**CITY OF TACOMA**  
**Public Works Engineering**

**ADDENDUM NO. 02**

**Request for Bids Specification No. PW20-0261F**

**S 19<sup>th</sup> St Signal & Crosswalk Improvements at Yakima Ave and Tacoma Ave**

SG-04 OF SG-06

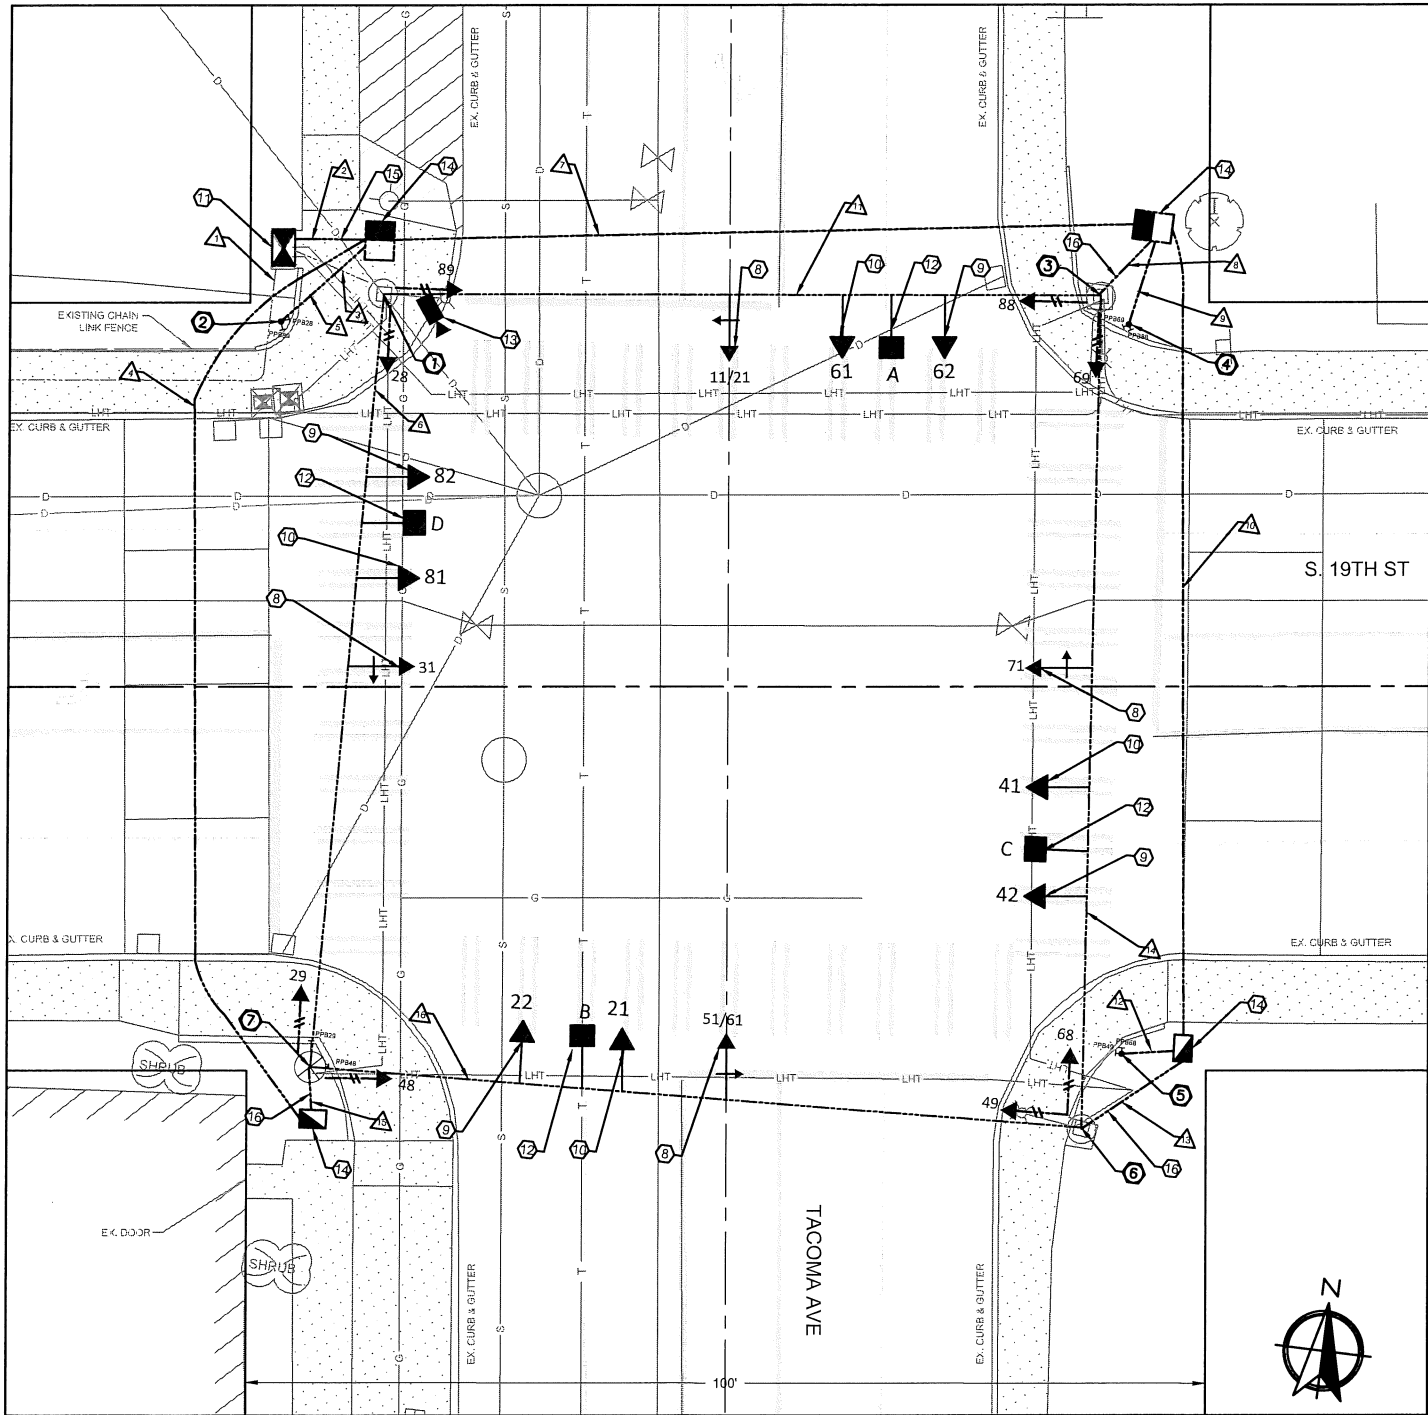
**Question 3: Most of the wire run numbers on plan sheets SG-01 and SG-04 are illegible. Can you upload new sheets with legible numbers?**

**Question 4: Plan Pages SG-01 & SG-04 are very blurry and we are unable to read wire notes or construction notes on these pages. When plans are enlarged they become blurred even further. Will another set of plans be published?**

**Question 5: On Sheets SG-01 and SG-04 many of the Wire Note numbers are not legible. I have tried downloading and enlarging the drawings but am still unable to read the numbers. Is there a clearer copy of these sheets that could be made available?**

Answer 3: SG-01, SG-03, SG-04, SG-06 have been rescanned to increase legibility.

Answer 4: SG-01, SG-03, SG-04, SG-06 have been rescanned to increase legibility.

Answer 5: SG-01, SG-03, SG-04, SG-06 have been rescanned to increase legibility.
